UNITED STATES
DEPARTMENT OF THE INTERIOR
BUREAU OF LAND MANAGEMENT

SUNDRY NOTICES AND REPORTS ON WELLS
Do not use this form for proposals to drill or to re-enter an
abandoned well. Use Form 3160-3 (APD) for such proposals.

8. Well Name and No. NM Federal Com 5 #1

**NM 5 Federal Com 1
30-005-62080
Summit Resources
May 28, 2019
Conditions of Approval**

Well: NM Federal Com 5 #1

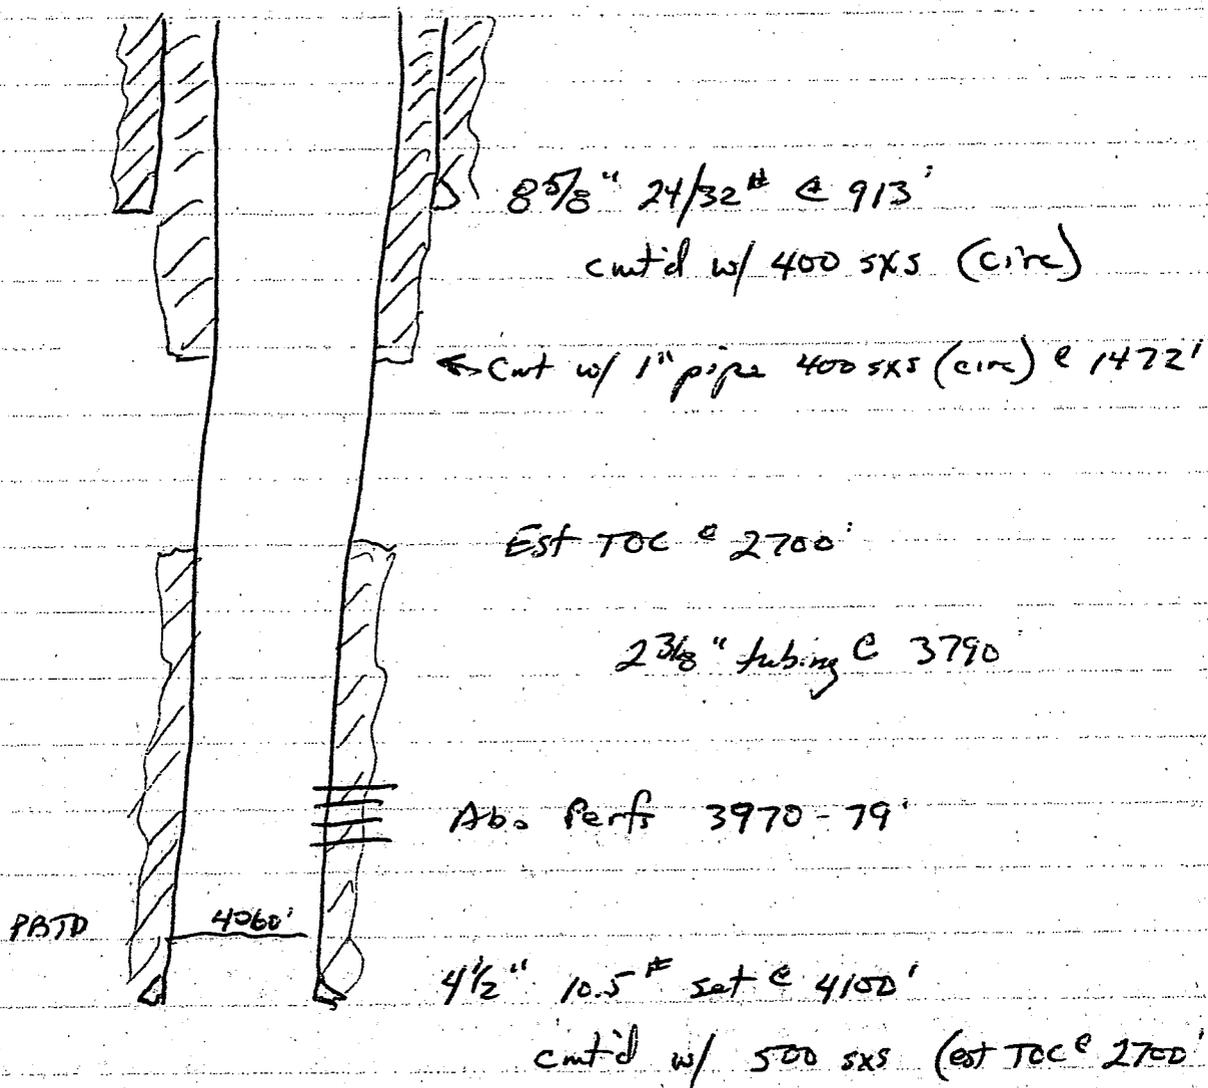
1. Operator shall place CIBP at 3,920' (50'-100' above top most perf) and place 25 sx of Class C cement on top as proposed to seal the top of the Abo Formation. WOC and TAG. Tag a minimum of 3500'.
2. Operator shall perf and squeeze at 2400' as proposed.
3. Operator shall place a balanced Class C cement plug from 1,600'-1,472' to seal the Glorietta Formation.
4. Operator shall place a balanced Class C cement plug from 963'-594' to seal the 8-5/8" shoe. WOC and TAG.
5. Operator shall perf and squeeze at 200'. Operator shall place a balanced Class C cement plug from 200'-surface to seal the Salt formation.
6. See Attached for general plugging stipulations.
